Agenda
Village of Arlington Heights
Design Commission
Community Room, 3rd Floor

- A. DC#18-106 - Dunkin/Baskin Robbins - 105 W. Dundee Rd. / Commercial
- B. DC#18-108 - 7-Eleven Gas Station - 1650 W. Algonquin Rd. / Commercial

It is recommended that the Design Commission approve the proposed architectural design for Dunkin' / Baskin Robbins located at 105 W. Dundee Road. This recommendation is subject to compliance with the plans received 11/27/18, Design Commission recommendations, compliance with all applicable Federal, State, and Village codes regulations and policies, the issuance of all required permits, and the following:

It is recommended that the Design Commission approve the proposed design for 7-Eleven located at 1650 W. Algonquin Road. This recommendation is subject to compliance with the revised plans received 12/21/18, Design Commission recommendations, compliance with all applicable Federal, State, and Village codes regulations and policies, the issuance of all required permits, and the following:

EXTERIOR COLOR
ELEVATIONS AND
SCHEDULE

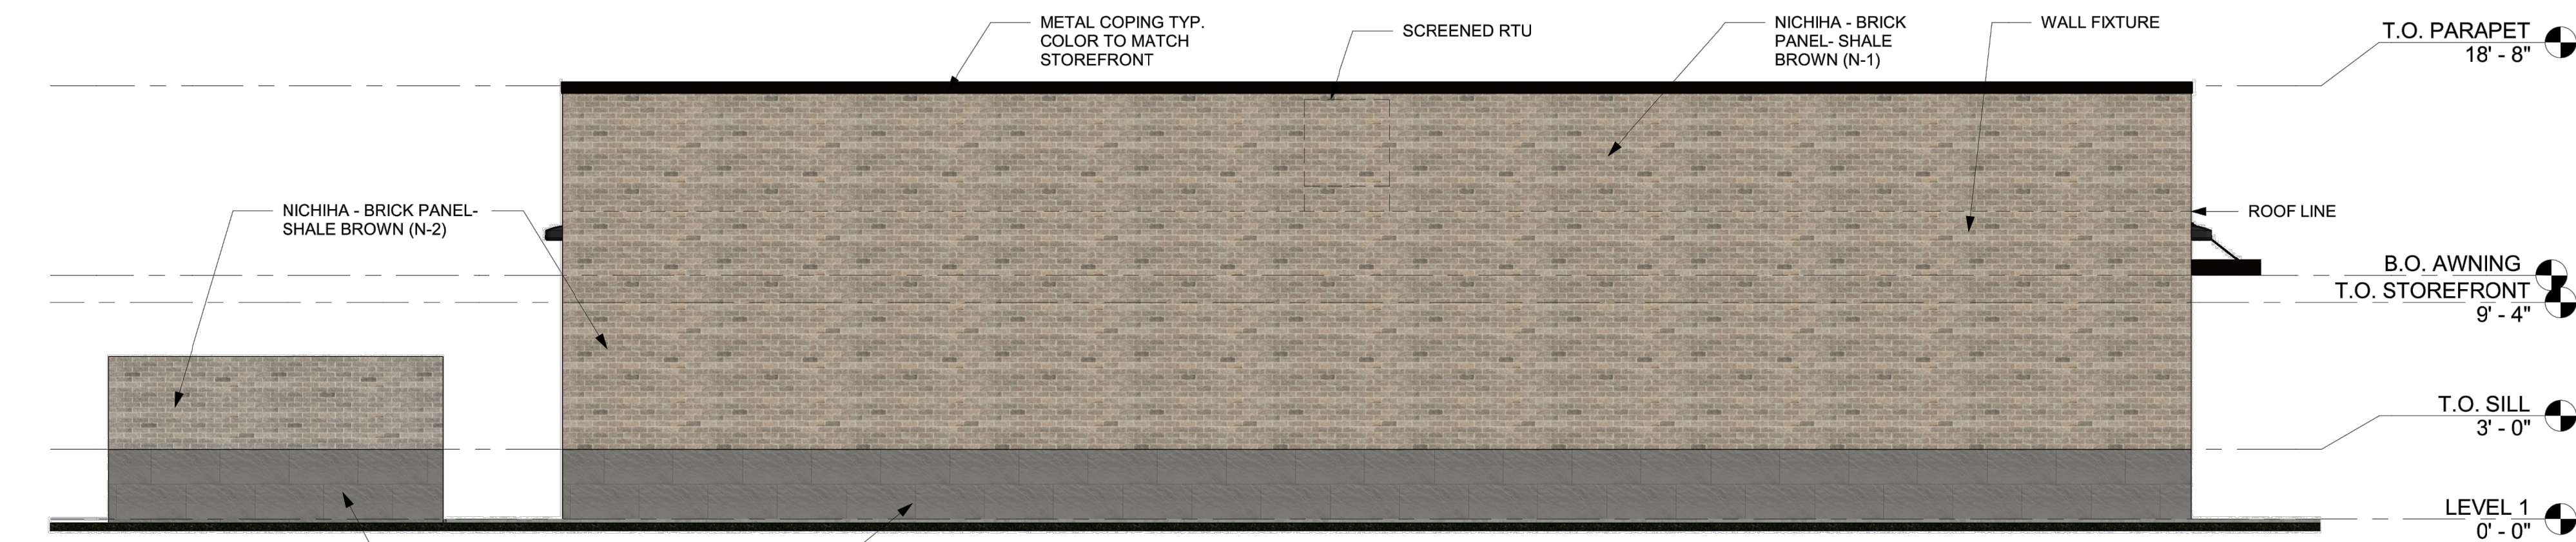
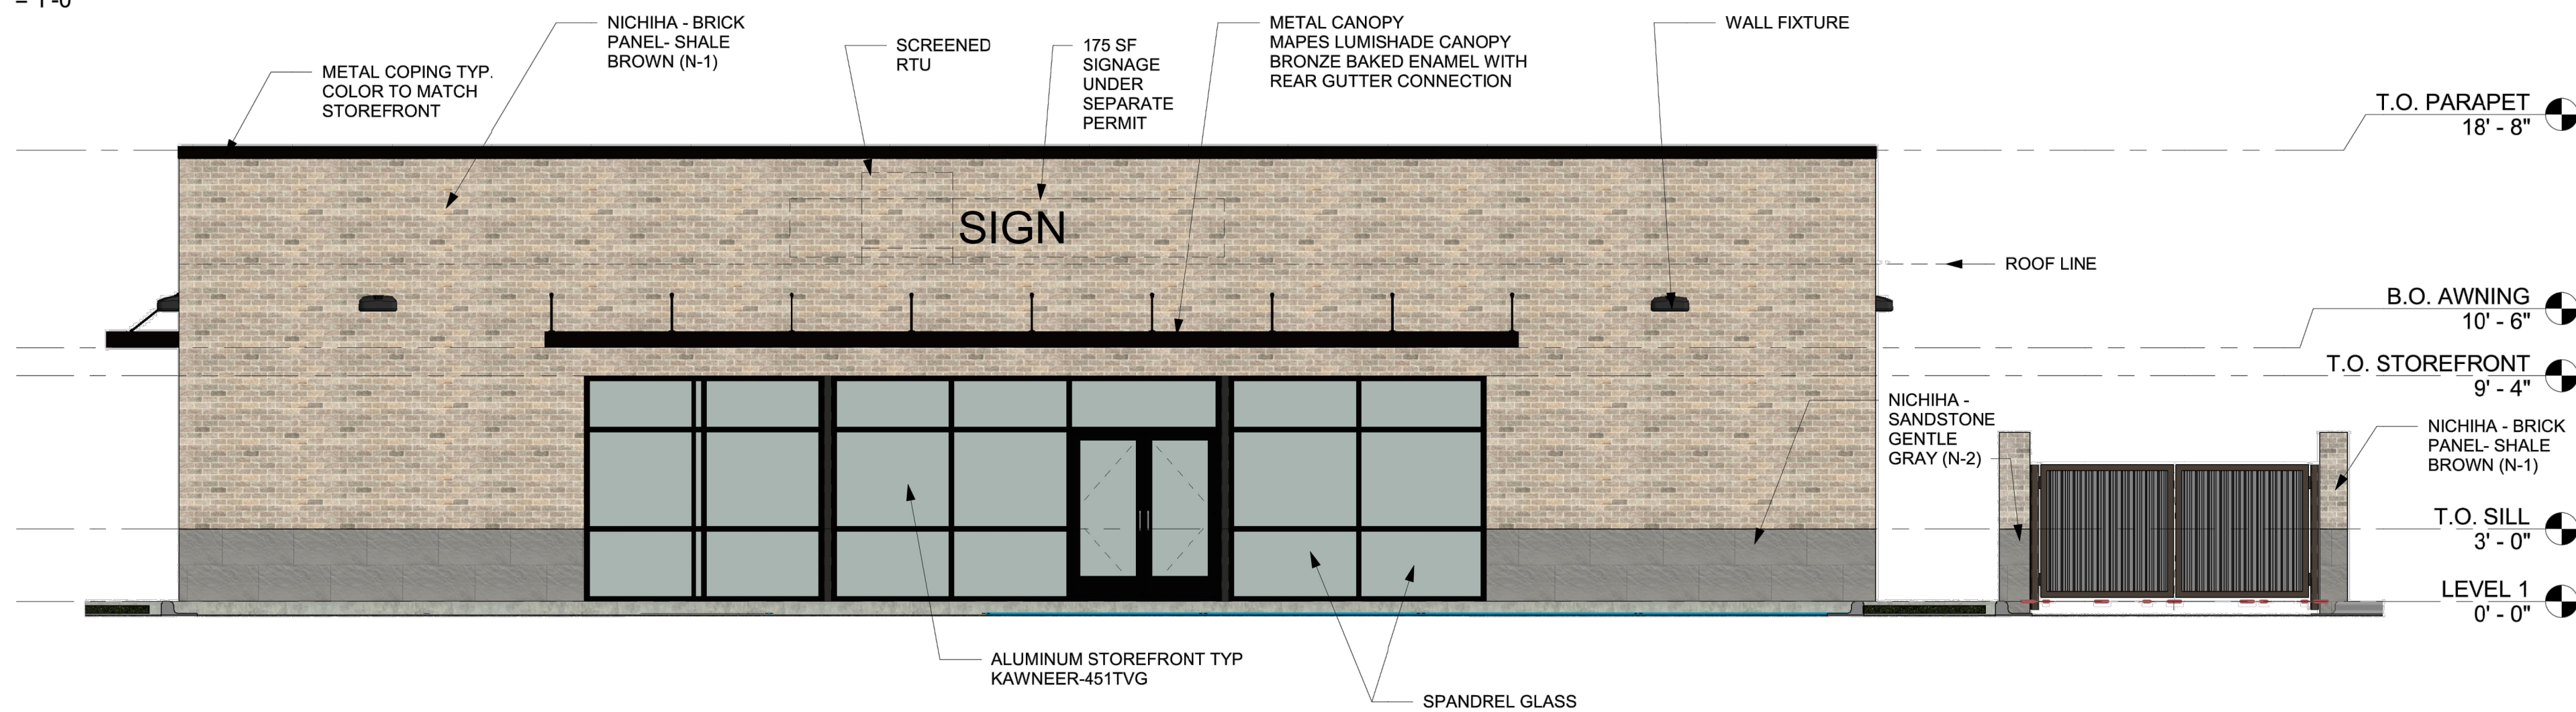
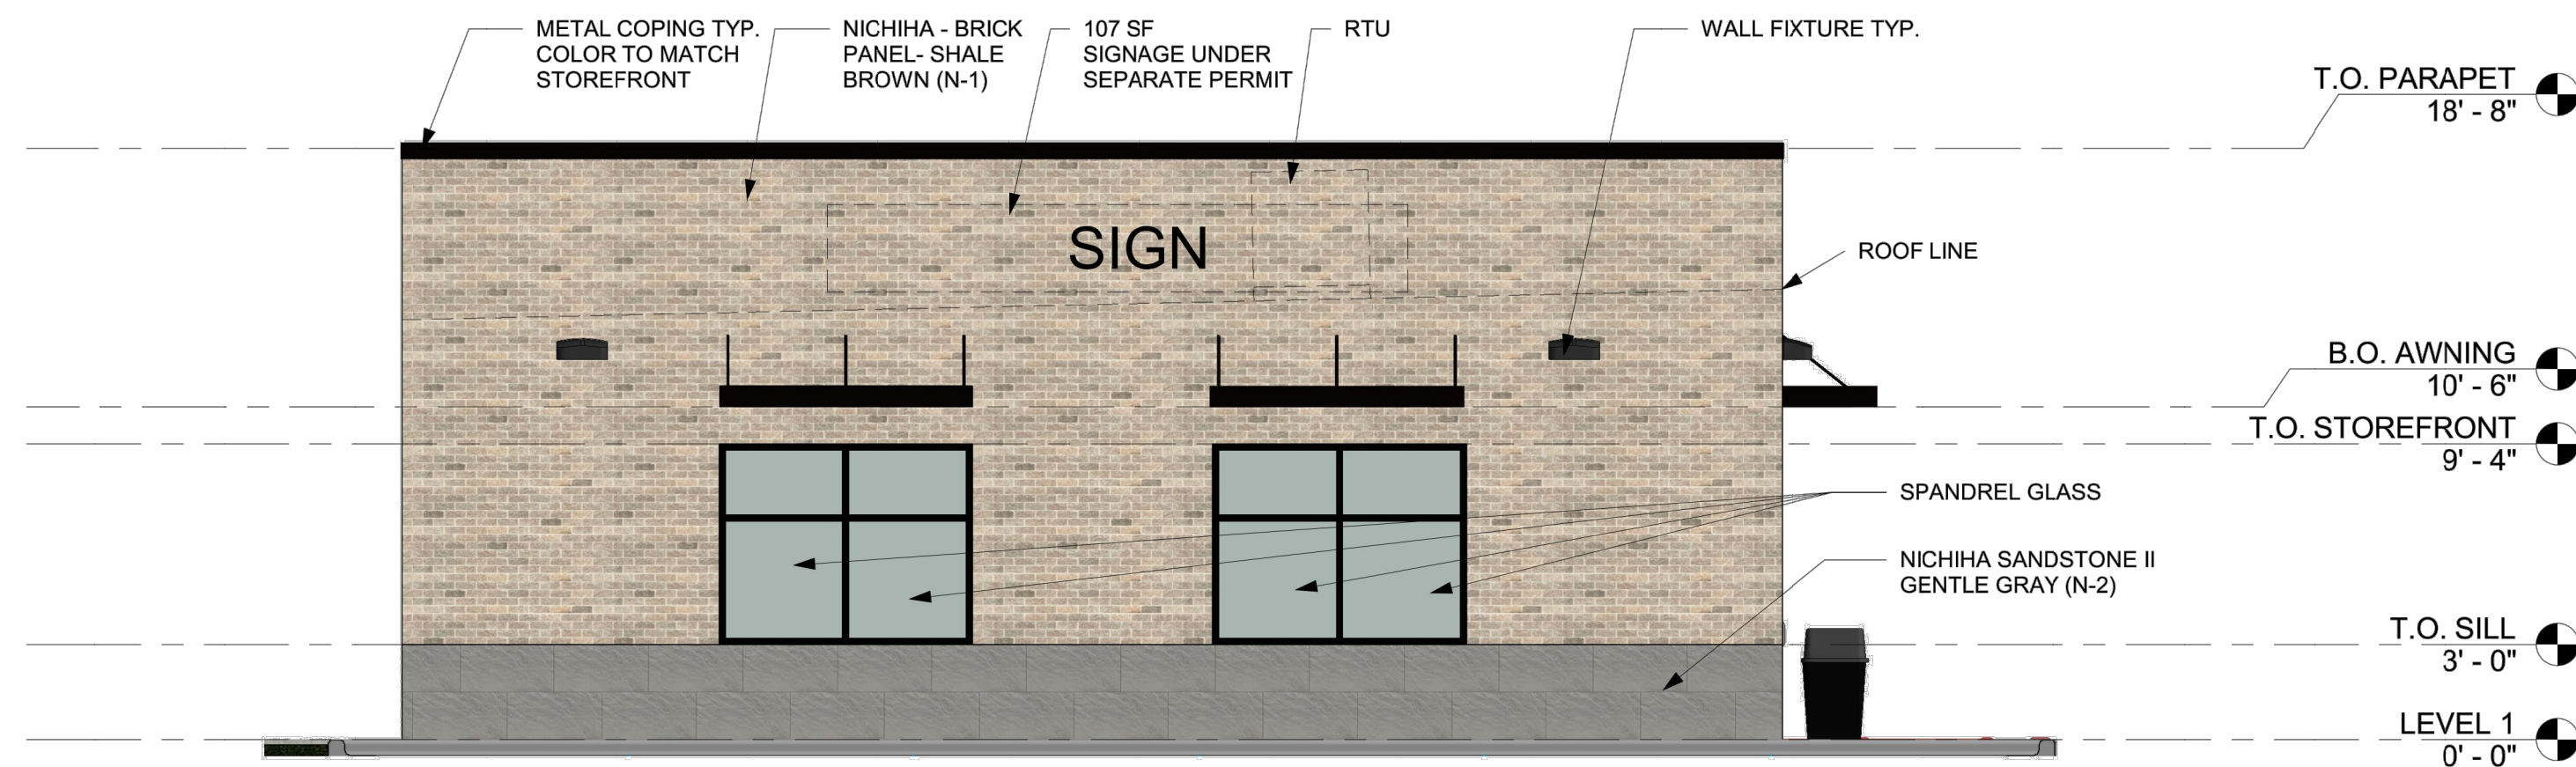
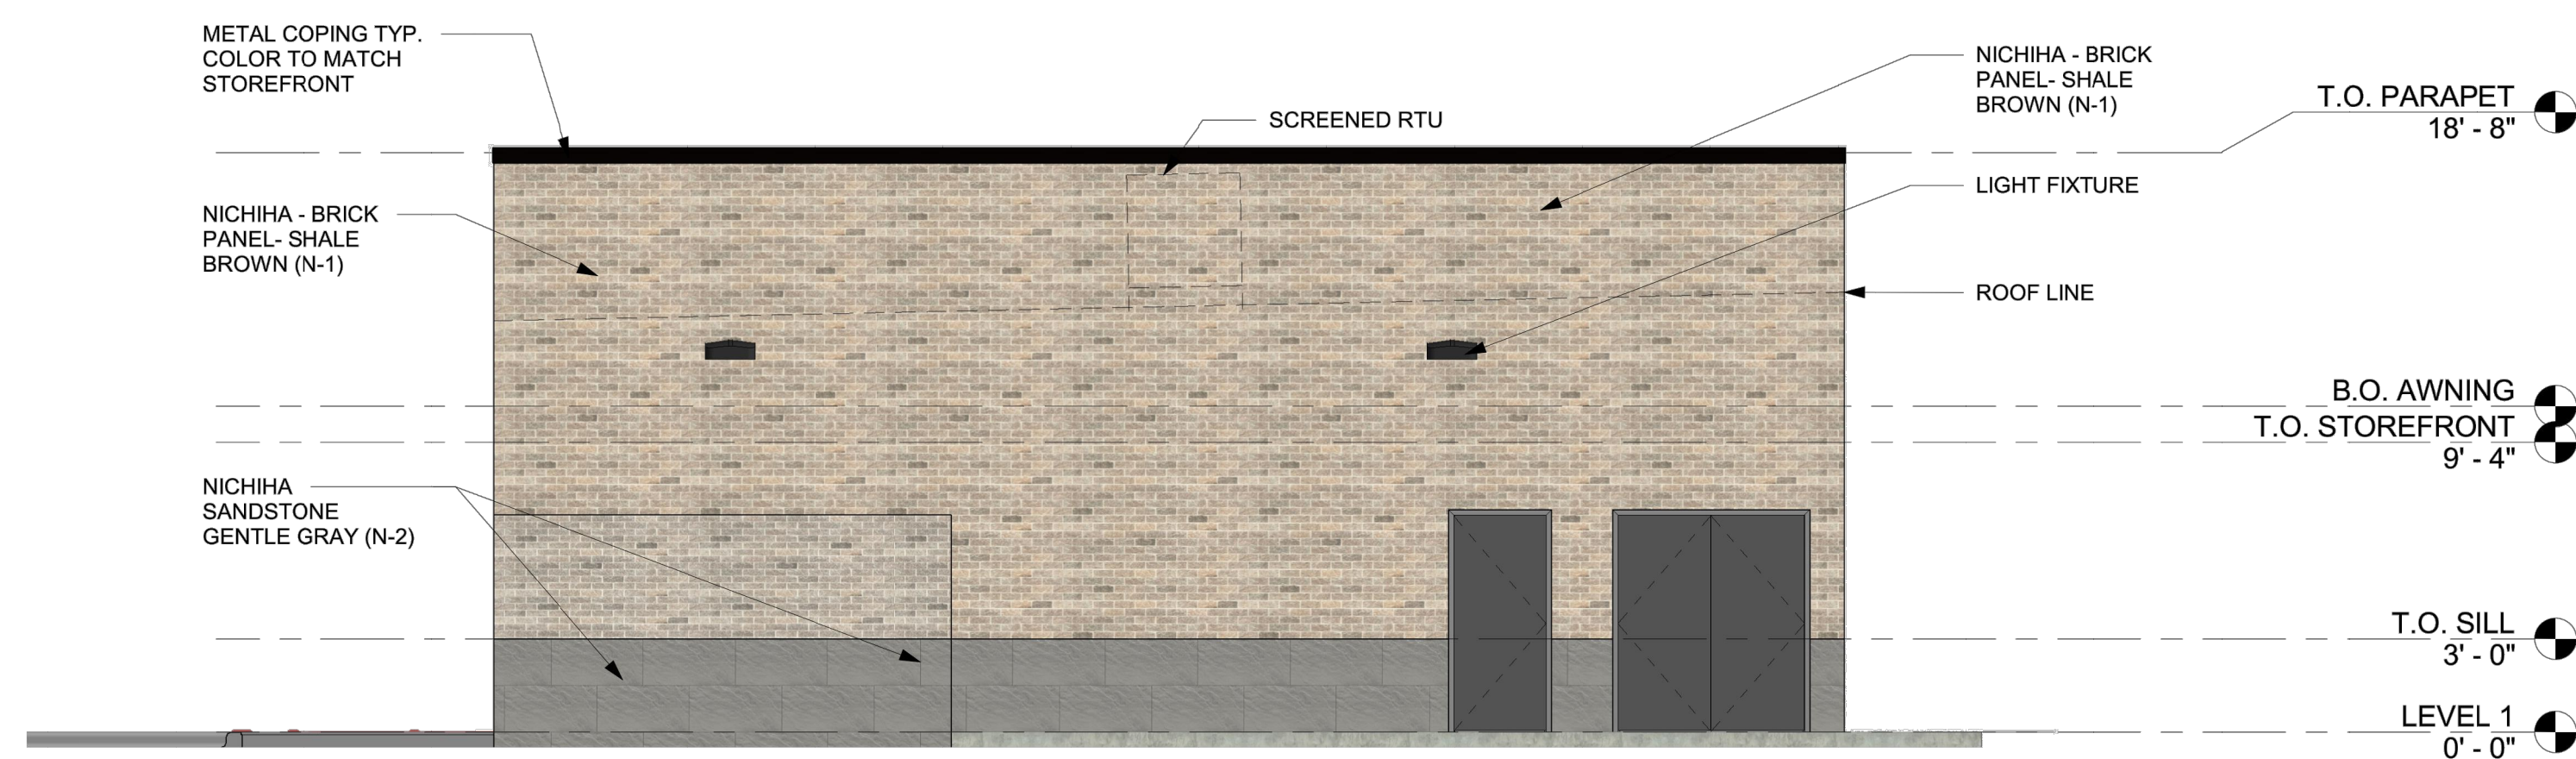
2. Consider omitting the stone panel detail on the fuel pump canopy columns and trash enclosure, providing an all brick appearance.
3. Signage shall comply with Chapter 30, Sign Code.

- The flush transition between the fiber cement "stone" base panels and the upper fiber cement "brick" wall panels looks too flat and has a fake appearance. It is recommended that a projecting sill trim piece be included between the two materials for a more authentic appearance. Consider using an adhered cultured stone sill detail.
- The stone base panels on the trash enclosure and canopy columns have a heavy appearance. Consider omitting the stone panel details on these items, providing an all brick appearance.

2. Consider omitting the stone panel detail on the fuel pump canopy columns and trash enclosure, providing an all brick appearance.
3. Signage shall comply with Chapter 30, Sign Code.
